Subject : Upper Shock Mounting Hardware

Applies To : Fire Truck IFS 20k and 24k Models

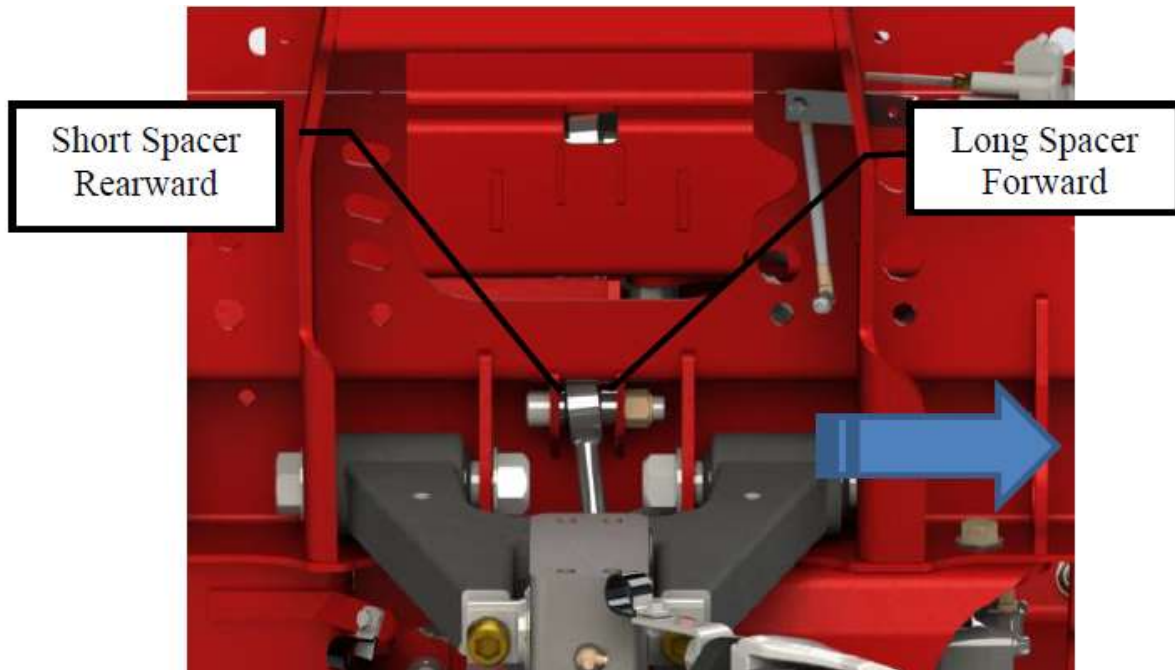
Condition : The upper shock mounting hardware may include spacers made of in-correct material.
This may cause shock mounting to become loose and rattle at the upper connection to the cradle.

- 2 long spacers #714189-01
- 2 short spacers #714190-01
- 2 socket head bolts #709623-01
- 2 Nylock nuts #710356-01

1. Remove and discard upper shock hardware including spacers.
2. Install new hardware including spacers from kit# K714188 as shown below.
3. Before tightening hardware inspect for gaps over 0.030". Shim gaps larger than 0.030" with appropriate shim from kit.

Assembly tip; Inset bolt through rear tab enough to hang needed shims and short spacer, place shock in position, advance bolt to engage shock, position long spacer, push bolt through front tab, and install nut.
